Pulte Homes Response to  MNCPPC
Ten Mile Creek Limited Master Plan Amendment Presentations

April 17th, 2013

Relationship between Total Impervious Cover and Stream Quality
 - Modified From Schueler et al. (2009)

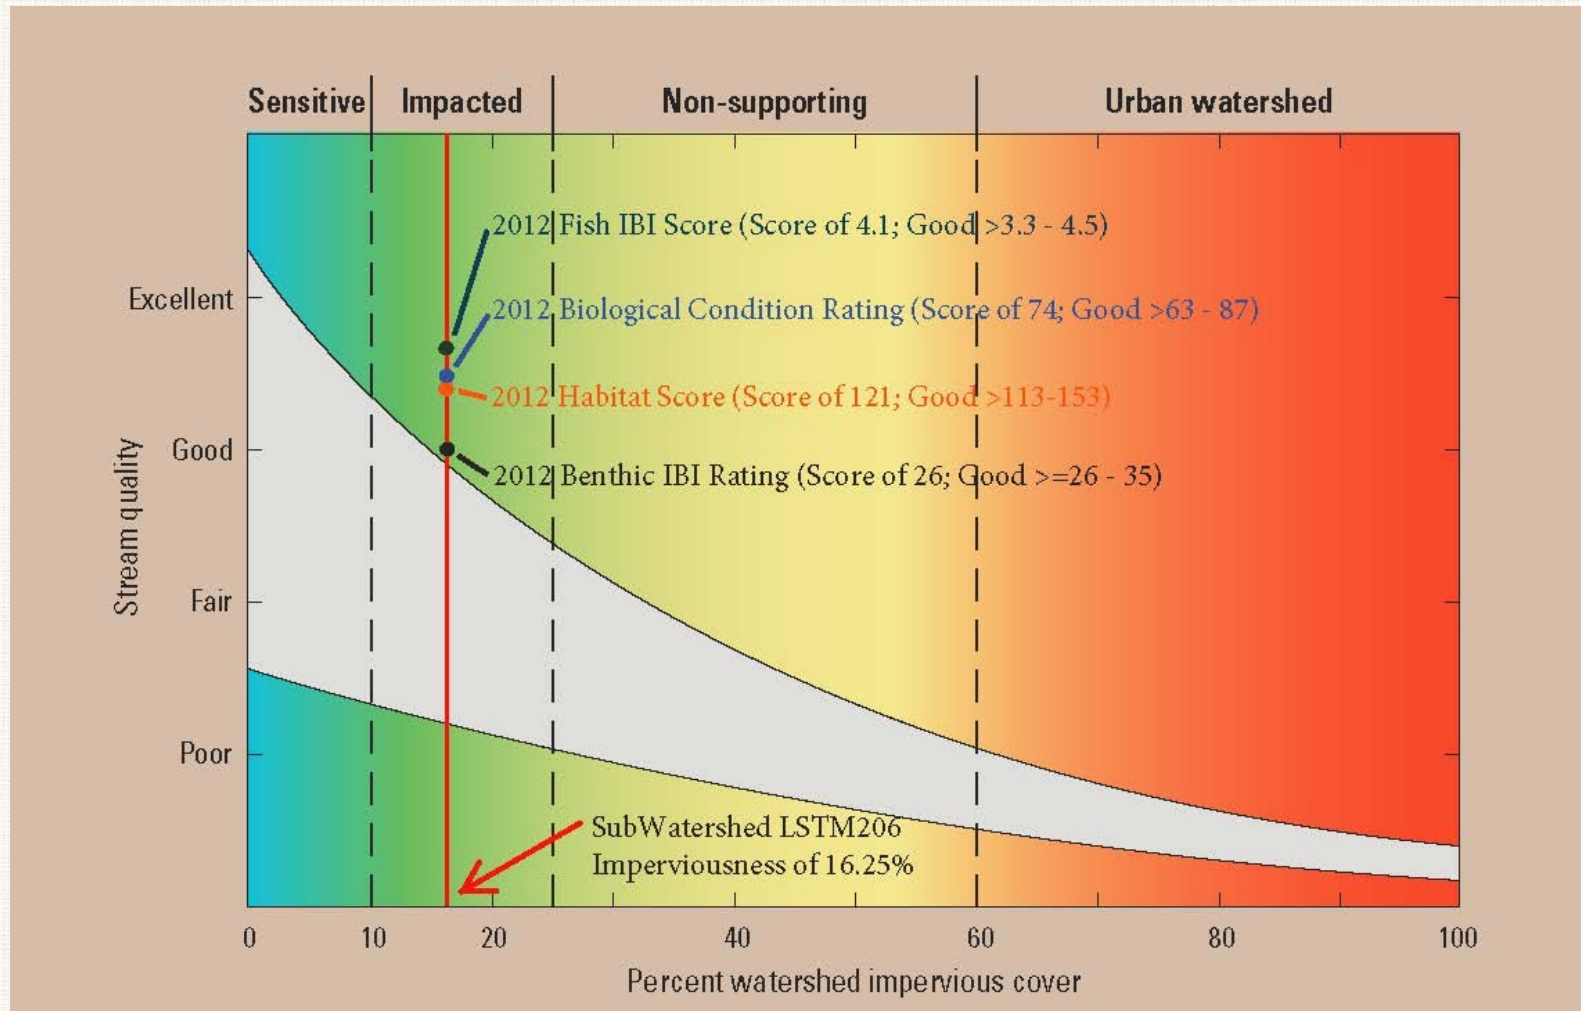
THE IMPERVIOUS COVER MODEL (ICM) IS NOT AN APPROPRIATE MANAGEMENT TOOL FOR TEN MILE CREEK

- ❖ Attempts to correlate effect levels / stream quality with varying degrees of watershed imperviousness
- ❖ Does not consider the effect of Environmental Site Design practices

MNCPPC MODEL 1

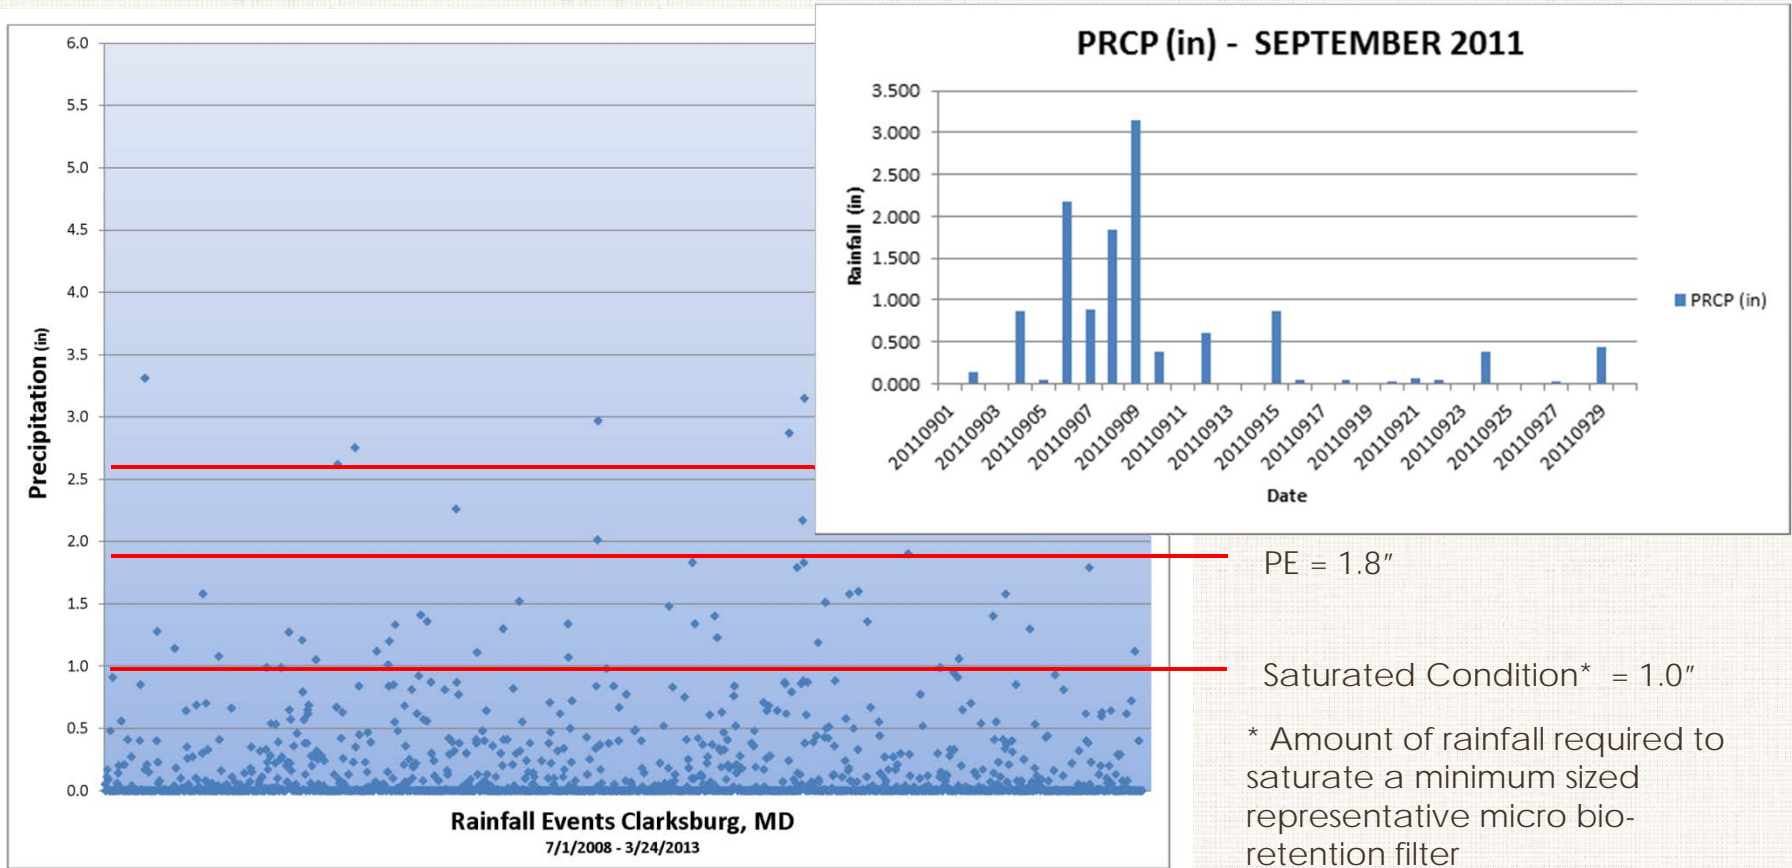
- ❖ 6" Ponding
- ❖ Minimum sized depth of 2'
- ❖ Saturated Condition within soil media
- ❖ HSG reduced by one category
- ❖ Underdrains placed above stone reservoir and discharge to surface waters

- ❖ Saturated Condition excluded volume within soil media from the model
- ❖ Volume within soil media represents 60-75% of the facilities overall volume in typical configuration

RAINFALL DATA CLARKSBURG MONITORING STATION

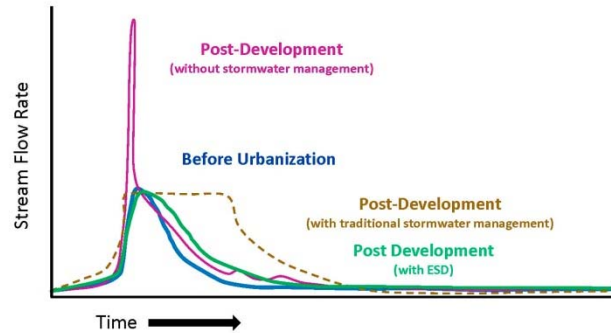
- ❖ The saturated condition of the ESD planting media during a 1-yr or 2-yr storm would have been met **only 1 time in 1586 rain events** in the last 5 years.

MNCPPC MODEL 1 HYDROGRAPH COMPARISON

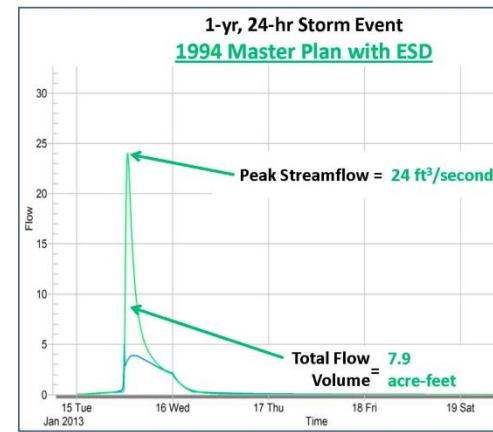
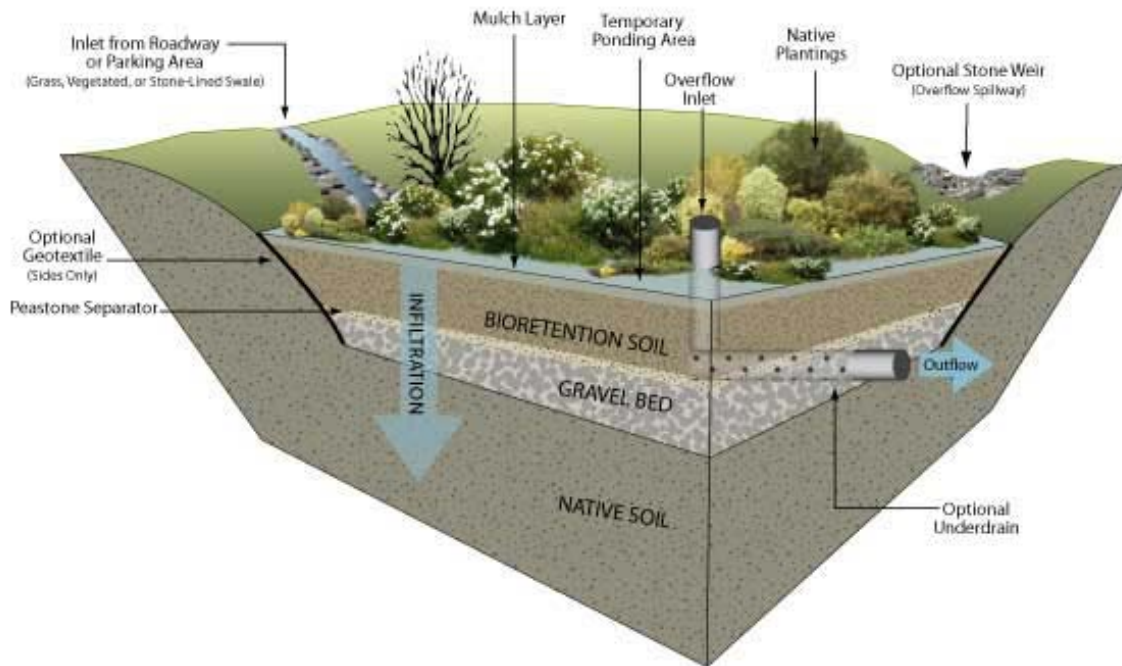
LSTM II0 Model 1 Hydrograph
Planning Board Work-session March 14, 2013

- ❖ LSTM II0 in Model 1 Hydrograph mimic the post-development (w/o SWM) hydrograph due to the saturated condition assumption.
- ❖ Saturated condition effectively removes the majority of storage volume for stormwater runoff

MNCPPC MODEL 2

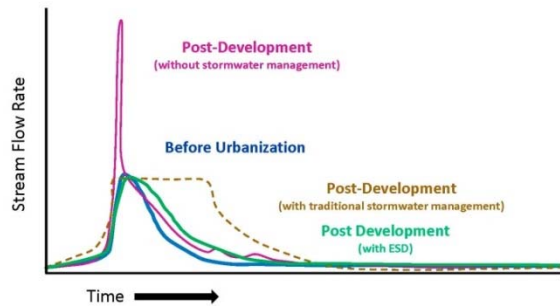
- ❖ 8" Ponding
- ❖ Minimum sized depth of 3'
- ❖ Maximum infiltration rate of 2" /hr and a minimum infiltration rate of .25" /hr with a decaying rate of 0.0015" /sec
- ❖ Constant infiltration rate of .025" /hr was used to represent the infiltration from the soil
- ❖ HSG reduced by one category
- ❖ Underdrains placed above stone reservoir and discharge to surface waters

- ❖ Ponding and media depth assumption have changed but it is still unclear as to overall volume assumption and whether the volume changed between the models
- ❖ Extremely low infiltration rate below system results in little to no groundwater infiltration within model response.

MNCPPC MODEL 2 HYDROGRAPH COMPARISON

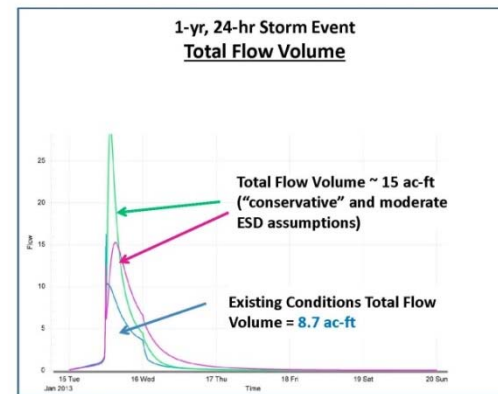
LSTM 110 Model 1 Hydrograph
Planning Board Work-session April 11, 2013

- ❖ Peak lowered due to the removal of saturated condition assumption.
- ❖ Total flow volume for LSTM 110 approximately same value under both models due to the assumption of an infiltration rate from soil media of .025"/hr; effectively providing no volume reduction via groundwater recharge
- ❖ Inclusion of volume reduction within the model would result in a hydrograph with a lower peak and narrower curve; similar to existing conditions/accepted post development (with ESD) hydrograph.
